Nº 143
SERVICE BULLETIN

SUBJ: **T3™ Software Update / Match Feature**

T3™

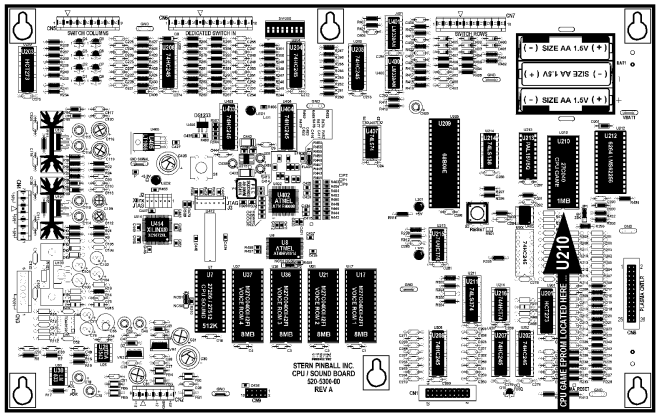
Symptom:

Game starts to produce only zeros (00) for the Match Number which appears at the end of every game. ***Note:*** *Only if Standard Adjustment **13**, Match Percentage, is set between **1%-10%** (Default is **8%**). If set at **0%** or **OFF**, you will not see the problem noted in this bulletin.*

When the Match % awarded exceeds the operators desired setting, the game will inadvertently display a "00" Match Number to prevent giving anymore Match awards *(depending on your setting of Standard Adjustment 12, Match Award, Default is Credit)*. It may also award a Match even if the numbers do not match.

CPU Game Code **V3.01+** *(SPI PN 965-0388-79)* will correct this issue. You can also download it from our website via www.sternpinball.com/techsupport.htm and click ROM CODE LIBRARY, then the game name or direct at www.sternpinball.com/rom.htm#12.

If your game already has v3.01 or higher, disregard this Service Bulletin (check the label on the EPROM at location U210 on your CPU Sound II Board).
